UNITED STATES PATENT AND TRADEMARK OFFICE

10/816,269

Office Action Summary

DETAILED ACTION

FIG. 19(a)

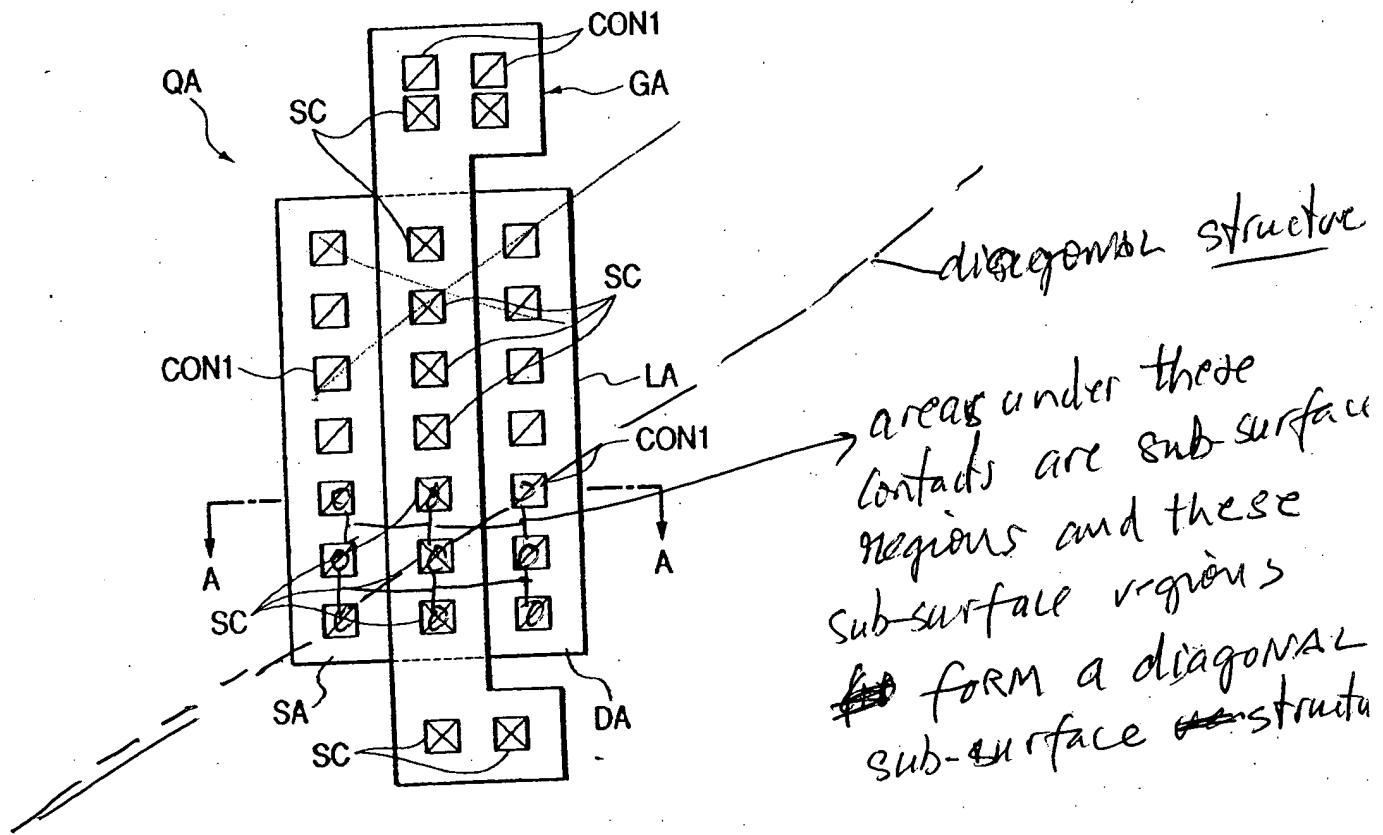
With respect to claims 1 and 21, Takahashi et al. teach a semiconductor device having a surface, comprising (see all disclosed figures, specifically figs. 19(a)-19(b), 20(a)-20(b), and 49 and associated text):

With respect to claim 12, Takahashi et al. further teach the first sub-surface structure is a first diagonal sub-surface mesh structure, and wherein said second sub-surface structure is a second diagonal sub-surface mesh structure. See figs. 19(a) and 20(a).

With respect to claims 2 and 22, Takahashi et al. further teach the sub-surface structure is a diagonal sub-surface mesh structure. See figs. 19(a) and 20(a).

In response to the applicant's arguments in the the paragraph bridging pages 16 and 17 and the first full paragraph on page 17 of the amendment dated 01/24/07, see the attached copy of examiner's explanation and interpretation of figs 19(a) and 20(a) of Takahashi et al.

FIG. 49

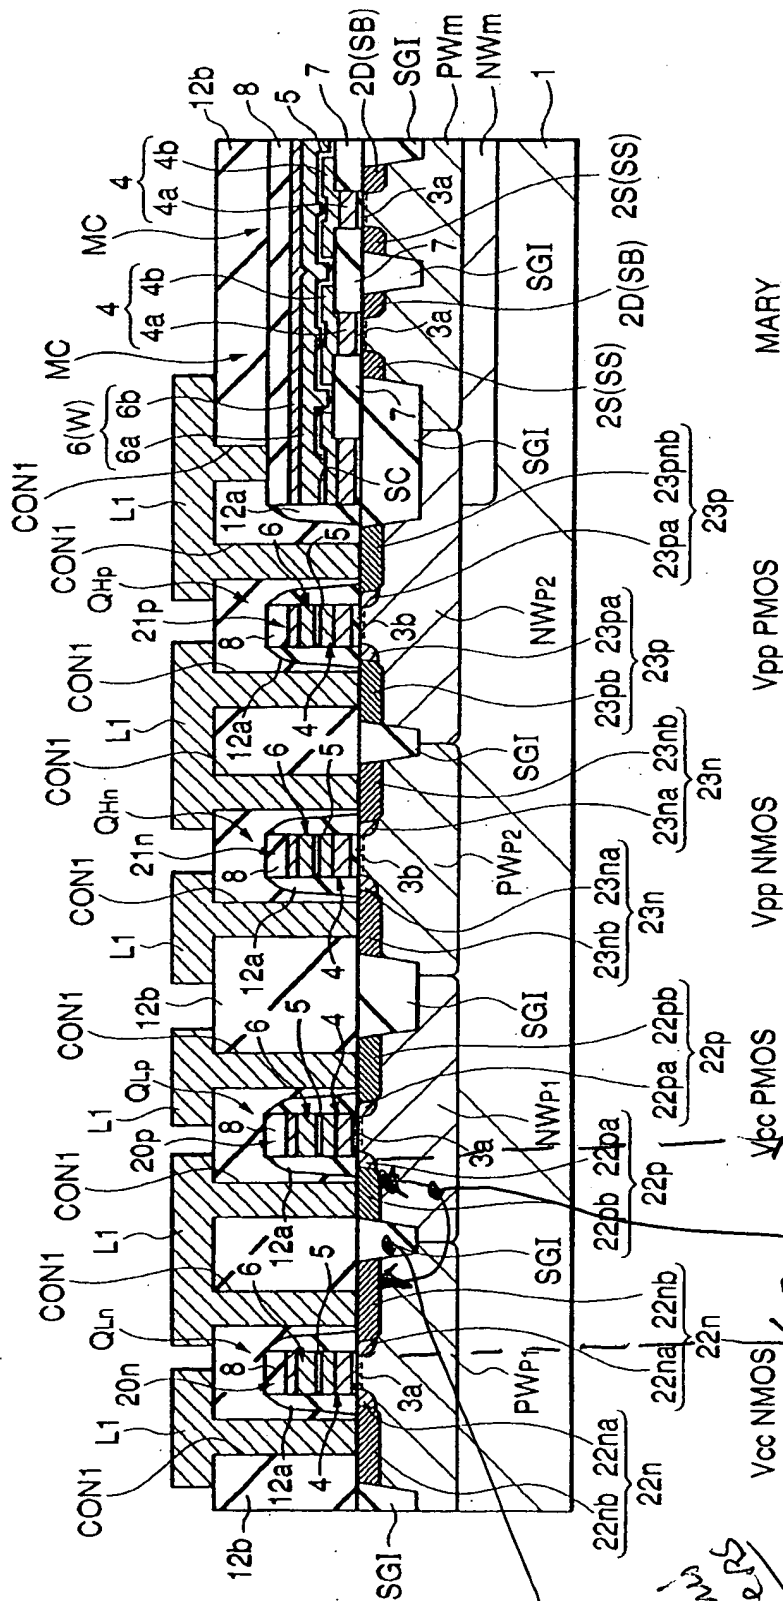
A plurality of conductive sub-surface regions 22nb, 23nb, etc. of a first conductivity each formed beneath said surface **of said semiconductor device**, wherein said conductive sub-surface regions form a sub-surface structure and said sub-surface structure has a perimeter (fig. 49);

With respect to claims 6, 7, 16, 17 26, and 27, Takahashi et al. further teach each conductive sub-surface region has an N-type or P-type doping. See fig. 49.

With respect to claims 8, 18, 28, Takahashi et al. further teach each conductive sub-surface region has a strip shape. See fig. 49.

With respect to claims 10, 20, 32, Takahashi et al. further teach a plurality of second conductive sub-surface regions 23nb of said first conductivity each formed under each portion of said metal structure that overlaps said sub-surface structure, wherein each second conductive sub-surface region has a continuous sub-surface layer shape. See fig. 49.

With respect to claim 33, Takahashi et al. further teach the isolation structure divides the sub-surface into a first portion and a second portion. See fig. 49.

With respect to claims 35, 40, and 45, Takahashi et al. further teach that the plurality of conductive sub-surface regions would inherently prevent the isolation of wells (PWp1, NWp1, PWp2, NWp, etc) 2of the semiconductor device since they provide conductive path. See figure 49.

With respect to claims 37, 42, and 47, Takahashi et al. further teach that the isolation structure SGI creates a gap that separates the conductive sub-surface regions to at least two regions. See figure 49.

With respect to claims 38, 43, and 48, Takahashi et al. further teach that the isolation structure SGI creates a gap that interrupts the conductive sub-surface regions to at least two regions. See figure 49.

In response to the applicant's arguments in the first and second full paragraphs on page 14 of the amendment dated 01/24/07, see the attached copy of examiner's explanation and interpretation of fig. 49 of Takahashi et al.

perimeter
isolation
structure
impurity

perimeters
defined on the
sub-surface structure
subregions or sub-surface structure
